**ADDENDUM NO. 3
TO THE
CONTRACT DOCUMENTS
FOR**

**City of Port Orchard, Washington
MCCORMICK WOODS WELL 11 SITE IMPROVEMENT PROJECT**

ISSUED THIS 17TH DAY OF JULY 2023.

SHEET M-1

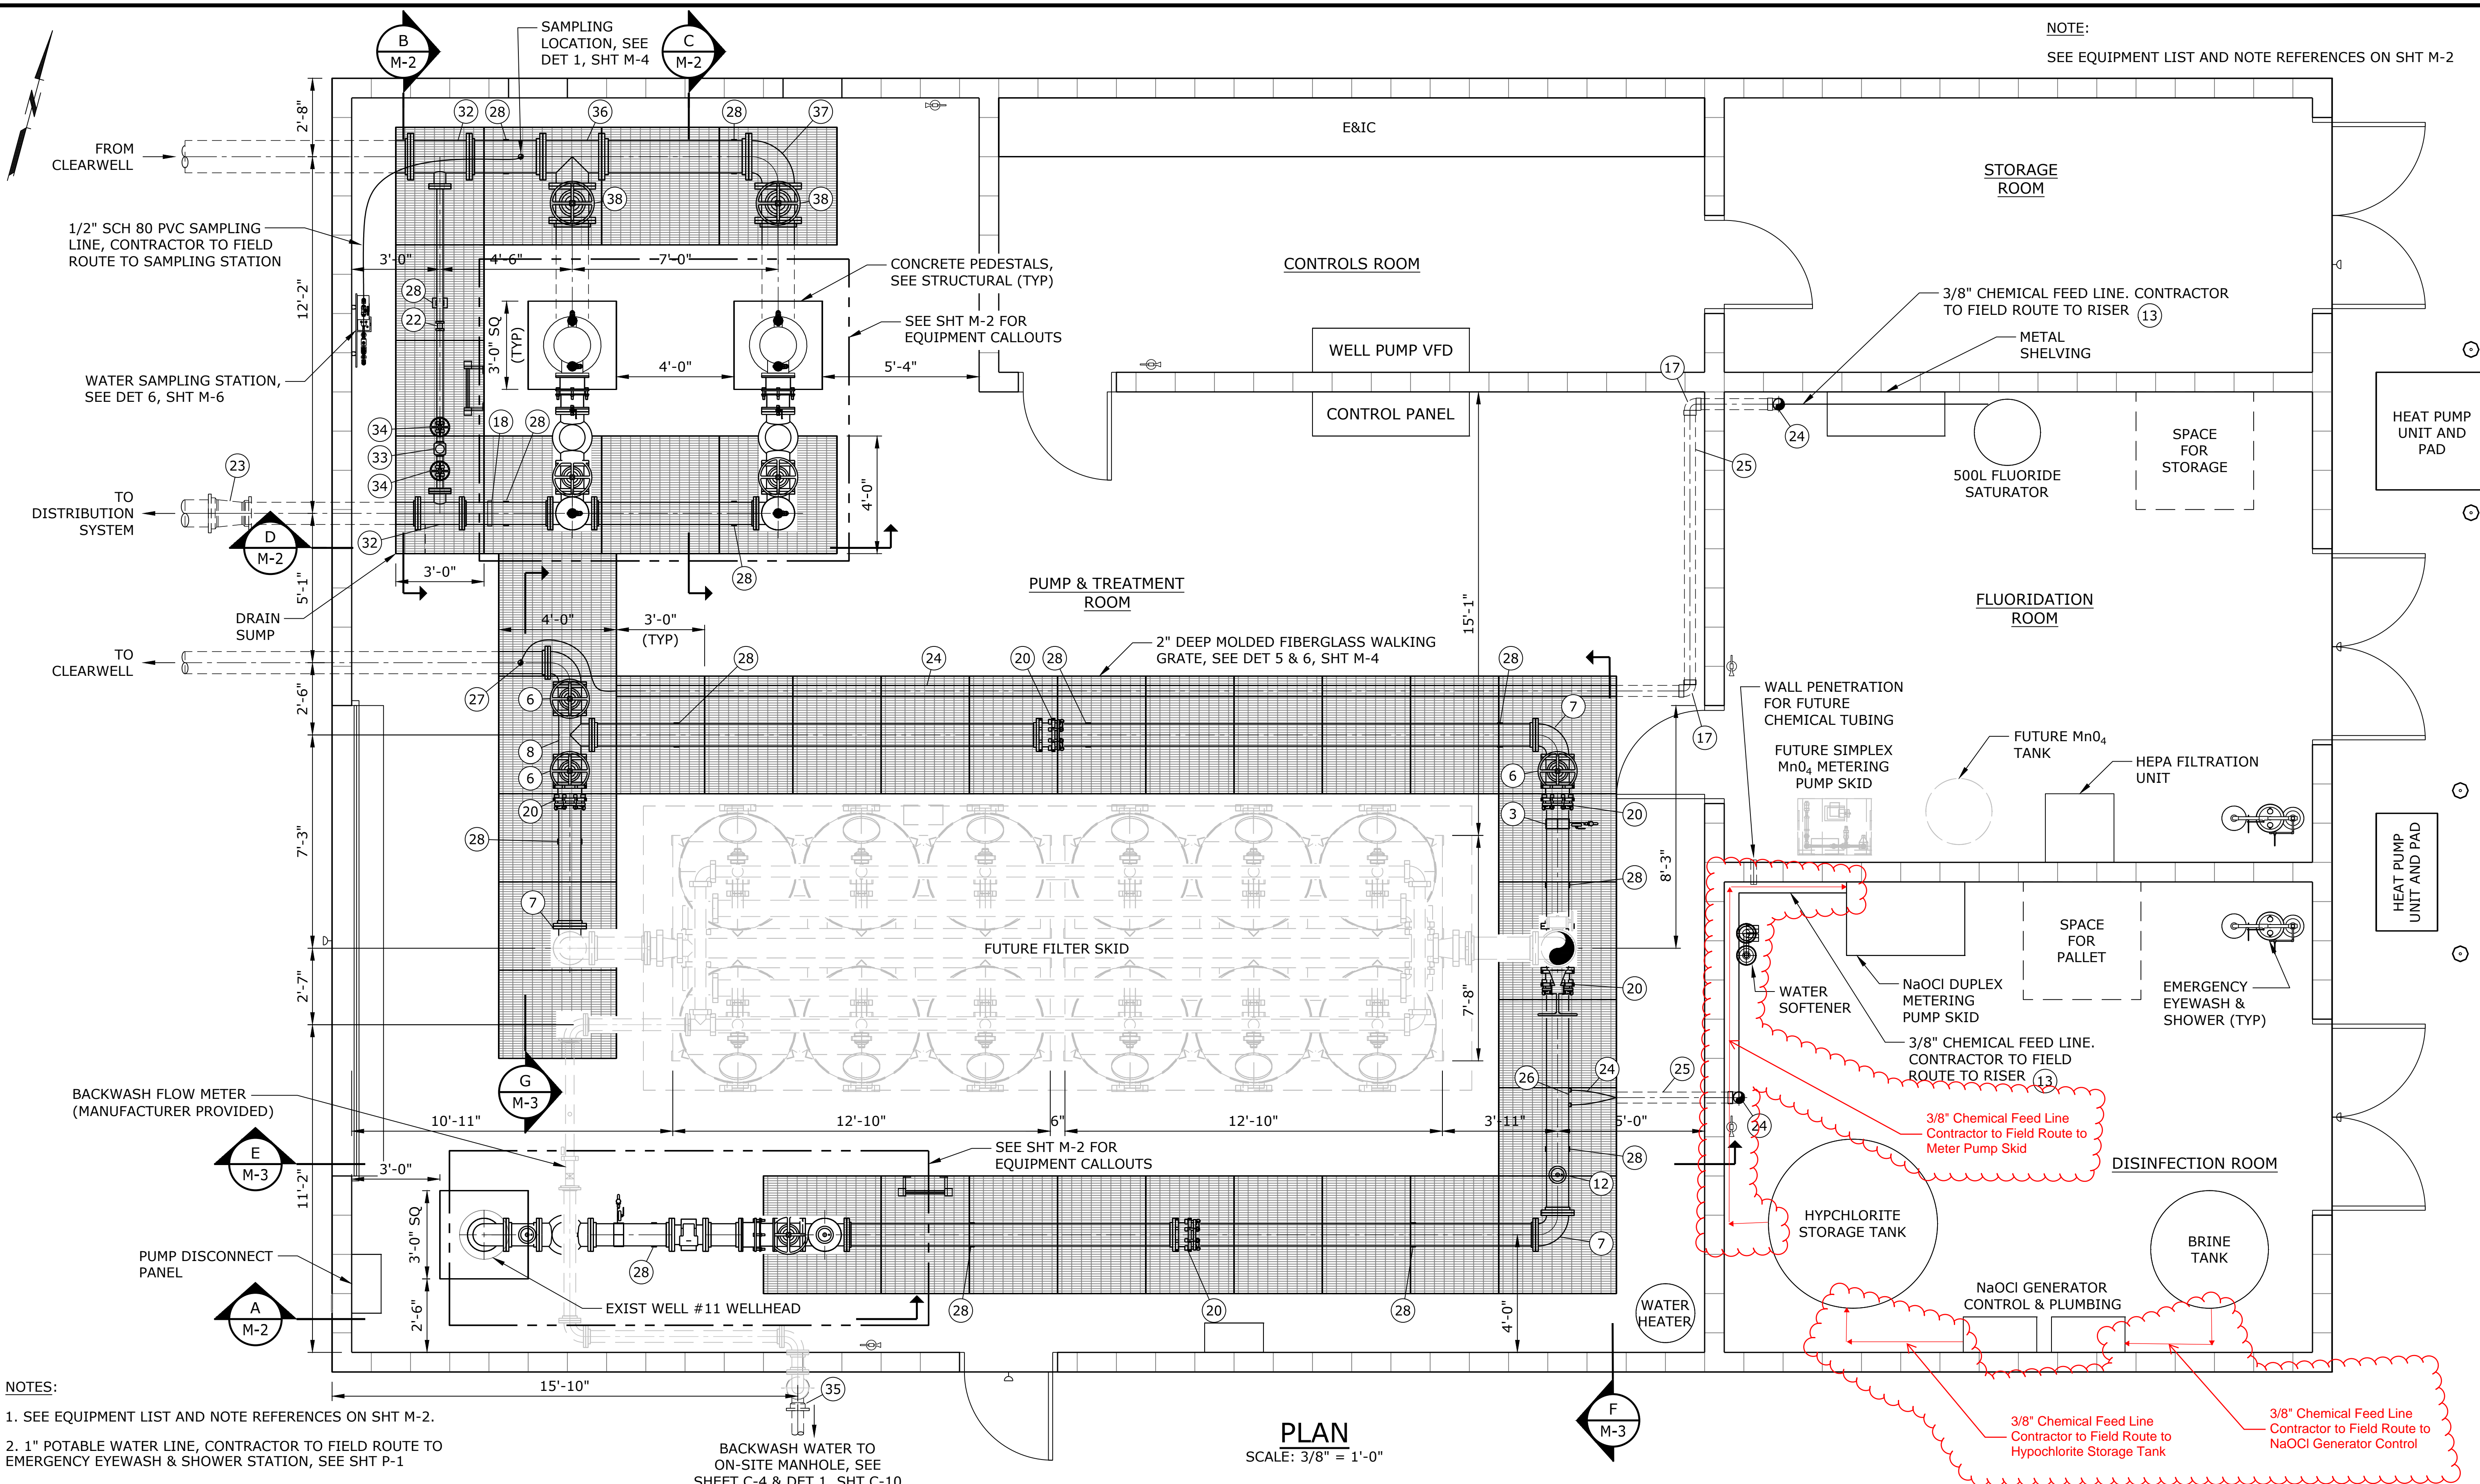
- a. The water heater will connect to the Emergency Eye Wash & Showers with 3/4" copper piping.
10. "Chemical system piping is not shown. Please provide schematic."

NO.	DATE	BY	REVISION
3	7/17/2023	PBC	Addendum 3 - added chemical feed lines

- a. See attached revision to M-3.
11. "Generator pad thickness is not shown."
 - a. Contractor's attention is directed to Detail 8/S-6.
12. "The discharge of the booster pumps appears to be 250lb flanges. Is the rest of the piping 250lb?"
